United States
Department of Defense

SUBJECT: Independent Engineering Assessment of the Army's Transportation Plan for BRAC Recommendation #133 Project Fort Belvoir - Mark Center, Virginia, (Report No. DODIG-2012-024)

**"Independent Engineering Assessment of the Army's Transportation Plan for BRAC
Recommendation # 133 Project Fort Belvoir – Mark Center, Virginia"**

Figure 4-2: Locations of Recommended Analysis Intersections

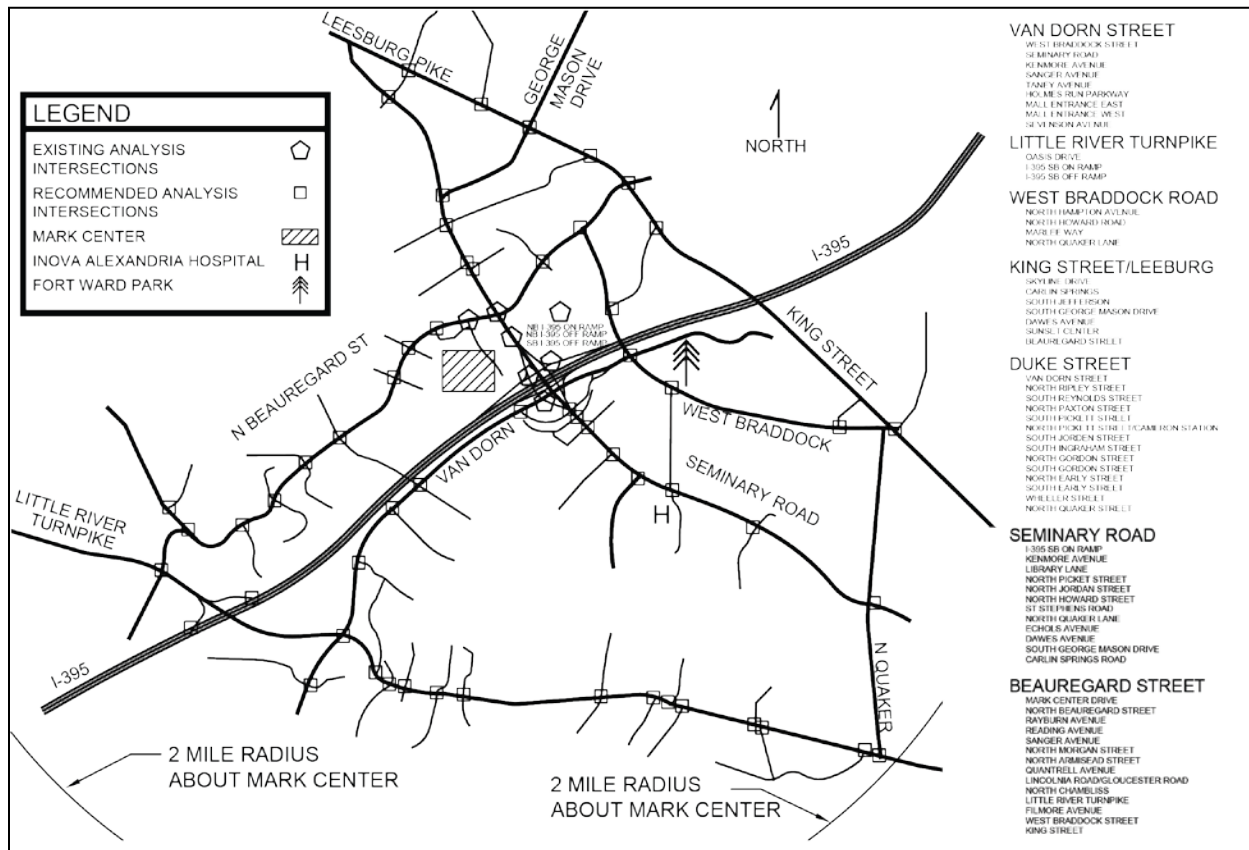
The six intersections analyzed are located in close proximity to the Mark Center and do not represent the full impact of BRAC 133 Project Fort Belvoir – Mark Center, Virginia. In limiting the extent of the study area to those six intersections, the Transportation Plan fails to comply with the requirements of the ITE Recommended Practice¹ as follows:

A map illustrating the location of these intersections and the two-mile radius is shown in Figure 4-2.

Figure 4-3: Independent Evaluation of the Roundabout

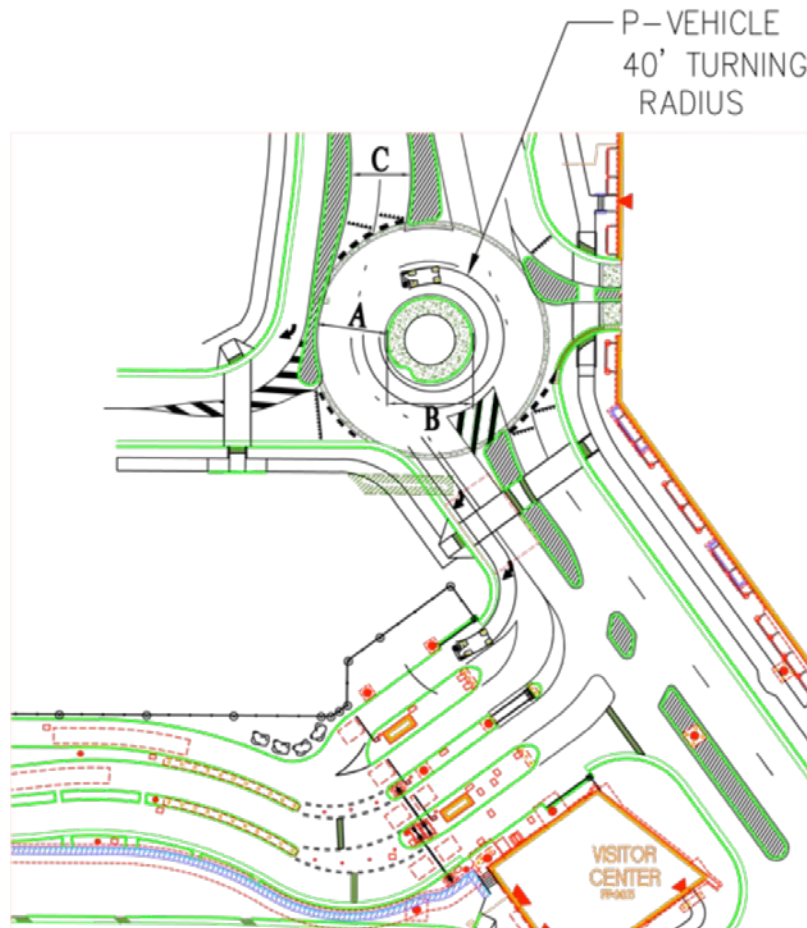
As shown in Figure 4-3 below, the roundabout was not designed consistent with standard design practice for roundabouts. The dimensions of the roundabout are not sufficient to provide efficient traffic flow through the roundabout and into the North and South Parking Garages as well as IDA Drive. These design deficiencies will result in inefficient circulation and unnecessary congestion.

As shown in Figure 4-3, the proposed WHS Circle roundabout is deficient in all the pertinent design parameters. According to the WSDOT Design Manual⁷, small changes in geometry can result in substantial changes in operational performance.

It is recommended that the designer revisit the design of the roundabout and make necessary changes to improve operational performance which will maximize gate processing operations and overall traffic circulation on WHS Circle.

Figure 4-6: Locations of Observed Pedestrian Service Deficiencies²

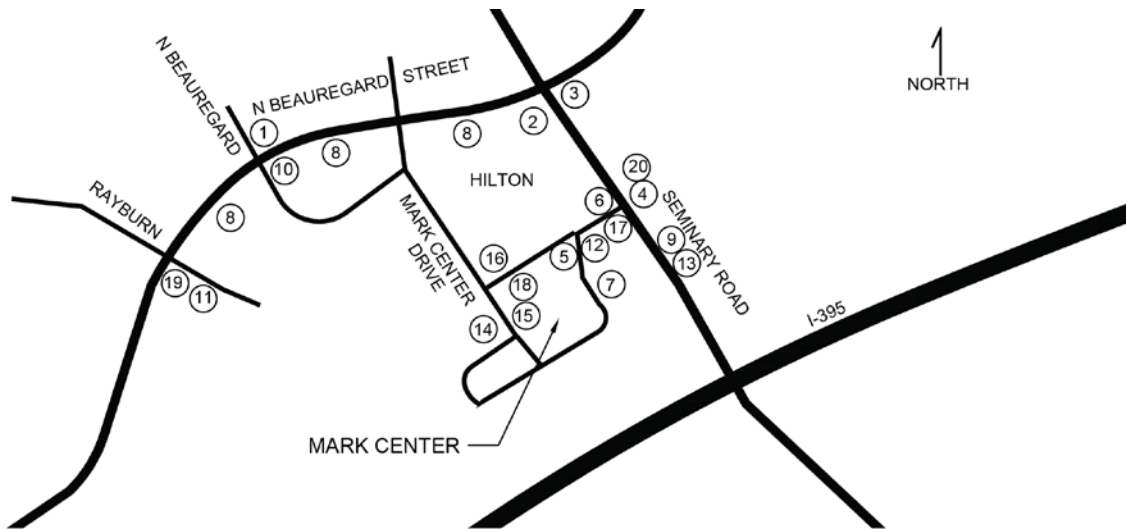
The deficient locations observed on the road network at and near the site are identified in Figure 4-6 below. Written descriptions of these locations is presented in the Appendix B: Table B-1: Pedestrian Service Field Observations At and Near the site of BRAC 133 Project Fort Belvoir – Mark Center, Virginia.

The Transportation Plan's assertion that "a well-connected continuous sidewalk system" will be available "before tenants begin occupying the BRAC 133 facility" (pg. 8, 4th bullet) is not correct. An August 2011 review inventory of pedestrian facilities at and near the site found a series of ADA-deficient and unsafe conditions including hazardous pedestrian crossing locations, substandard sidewalk widths, substandard bus stop locations, substandard crosswalk ramp facilities, substandard (or non-existent) pedestrian traffic control devices, and absence of pedestrian way finding. Additionally, the proposed Seminary Road pedestrian overpass has not been built, requiring BRAC 133 Project Fort Belvoir – Mark Center, Virginia, workers to cross the heavily traveled, multi-lane traffic arterial at-grade. This will make it difficult to safely accommodate the 128 employees expected to walk to the BRAC 133 Project Fort Belvoir – Mark Center, Virginia, work site on a daily basis.

The findings that the pedestrian facilities in and around the BRAC 133 facility are unsafe and ADA-deficient are incorrect. Due to the weight that a finding of "ADA-deficient" carries, the Army requests that this inaccurate characterization be deleted from the final report. Each item in Figure 4-6, found on page 72 of the Independent Engineering Assessment and titled "Locations of Observed Pedestrian Service Deficiencies" is addressed here:

- 1- Item listed on figure 4-6 but not discussed in commentary
- 2- Please note the pedestrian control devices noted in the photograph (fig. 2)
- 3- Please note the 6" protective curbing in the photograph (fig. 3)
